Description of change

FCC ID : YZP-VL1000

Base Model : LTD-VL1000

Variation Model : LTD-VL1110, LTD-VL1200

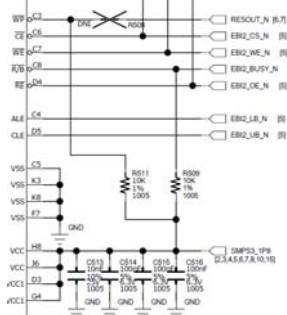
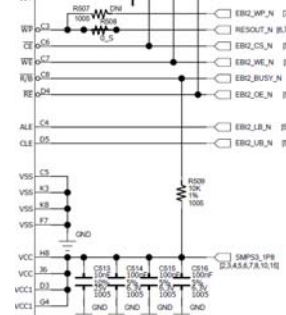
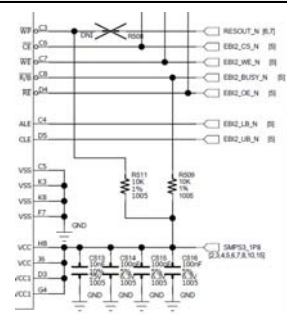
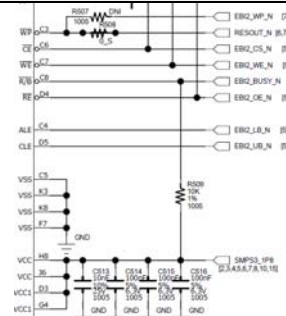
LTD-VL1110	LTD-VL1000	Description of changes
S34MS02G200BHI00 (SPANSION, 2G NAND)	S34MS01G200BHI00 (SPANSION, 1G NAND)	Memory change (1G→2G)
		Add the Pull-up resistor (R511) for stabilization of the NAND memory.
Removed the R507	DNI	For System stabilization

LTD-VL1200	LTD-VL1000	Description of changes
		Add the Pull-up resistor (R511) for stabilization of the NAND memory.
Removed R507	DNI	For System stabilization
